MKX²1083 LIFT-ASSIST INTERFERENCE – FIELD FIX BULLETIN

ECN ID #	4401
DATE	July 13, 2023
BRAND	Westfield
MODEL	MKX ² 1083
DETAILS	MKX ² 1083 lift-assist interferes with the lower truss bracket.

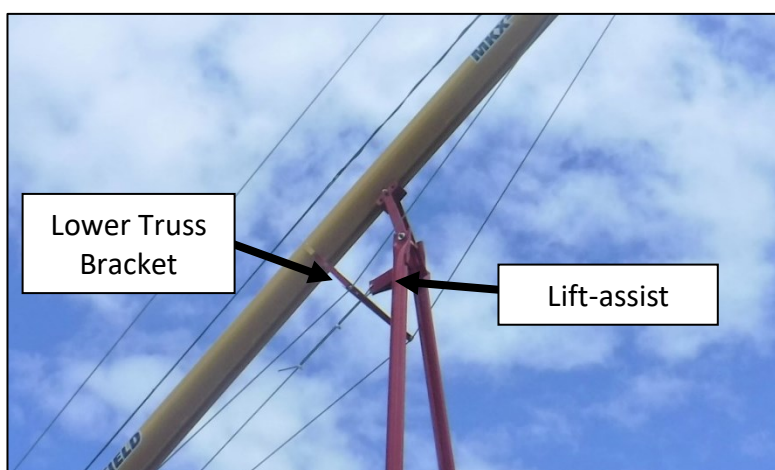
Many MKX2013 augers were shipped with the incorrect stroke limiter plate causing the lift-assist to interfere with the lower truss bracket when fully raised.

At the lift cylinder (part # 202679RD), replace the current stroke limiter plate (part # 202900RD) with the correct version (part # 202901RD). This will reduce the stroke and prevent the auger from lifting too high as to hit the lower truss bracket. **NOTE:** The lift cable length will need to be re-adjusted given the new resting state of the cylinder.
